**City of Woodburn**  
**Community Development Dept.**

**Date:** March 2, 2022  
**To:** Dago Garcia, P.E., City Engineer  
**Cc:** Chris Kerr, AICP, Community Development Director  
Craig Larson, PE, Project Engineer, Pacific Community Design  
**From:** Colin Cortes, AICP, CNU-A, Senior Planner *CC*  
**Subject:** **Planning Division review comments on 2<sup>nd</sup> submittal February 2 of civil engineering plans for Dove Landing PUD (ANX 2020-03)**

# DOVE LANDING CIVIL ENGINEERING PLANS

**SITE PLAN (WEST)**

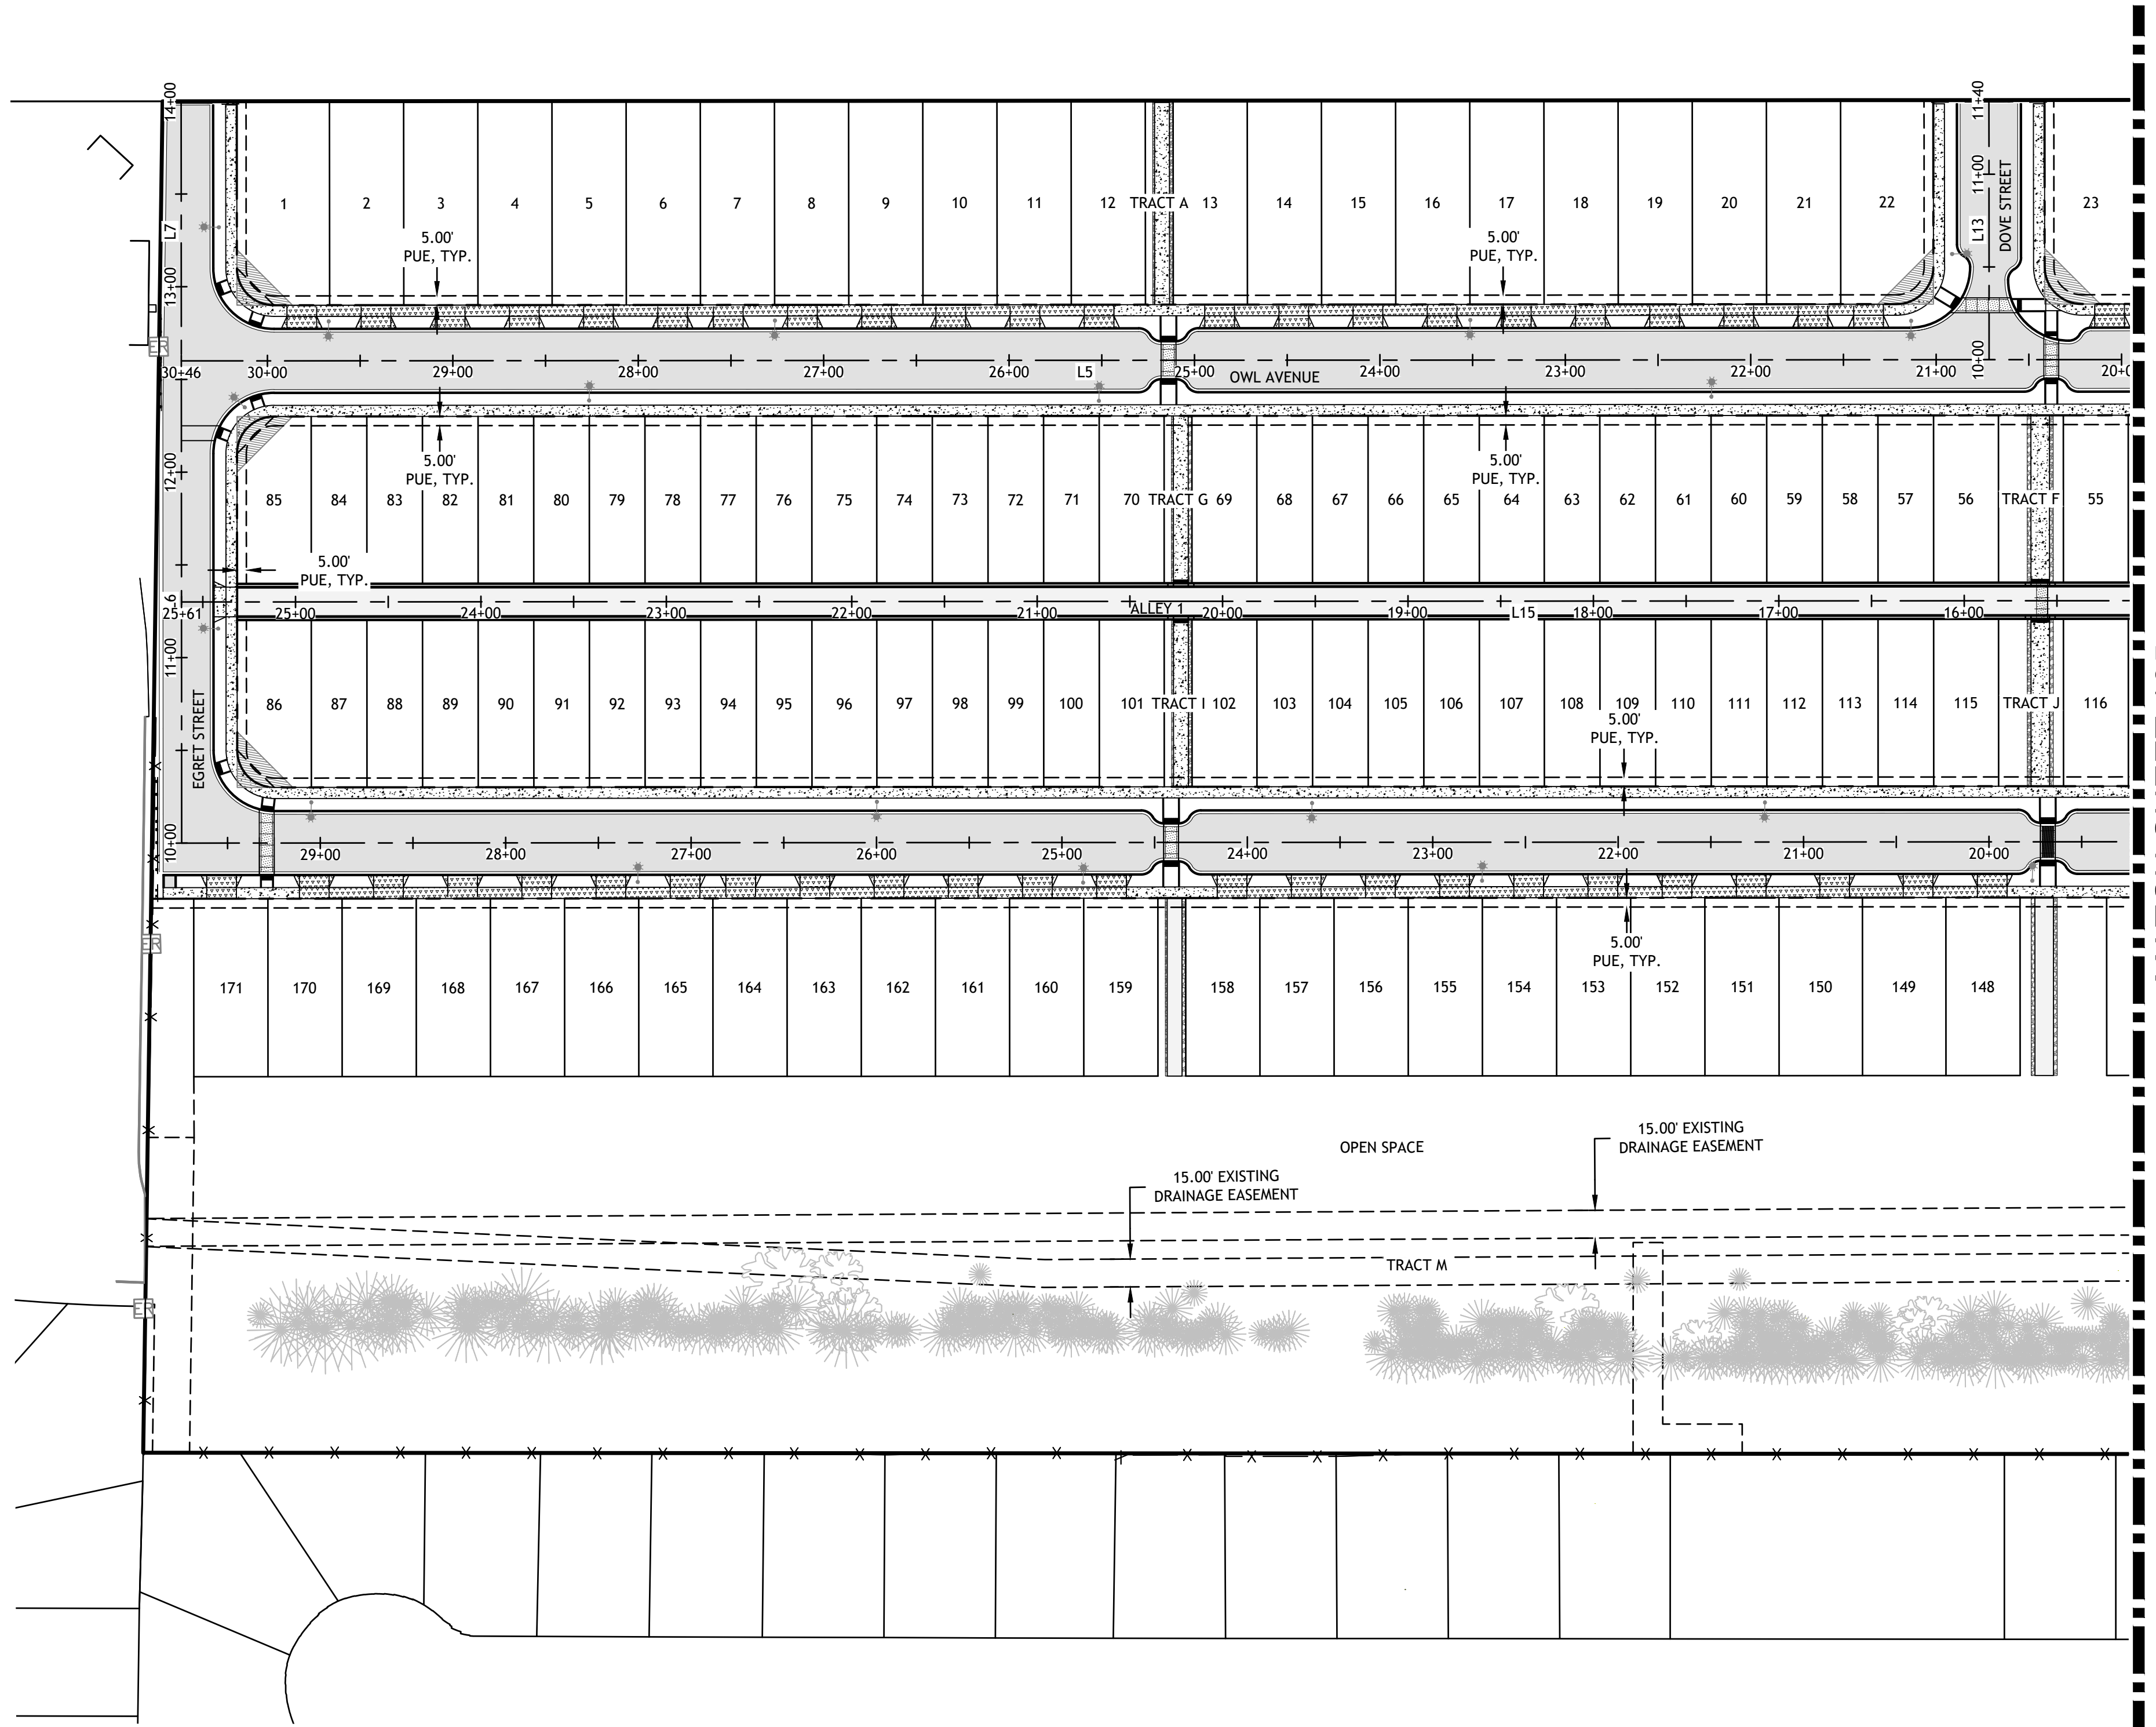
(2) Revise the civil set. It shows per Attachment 203 Part C2, regarding the southwest park tract (what was Tract K and is now designated Tract M), 2 of the 3 north spurs. It shows the east and middle ones, but not also the west one (near Egret St). Revise Sheets 104, 110, 206, 210, & SS1 and add a new sheet to F series.
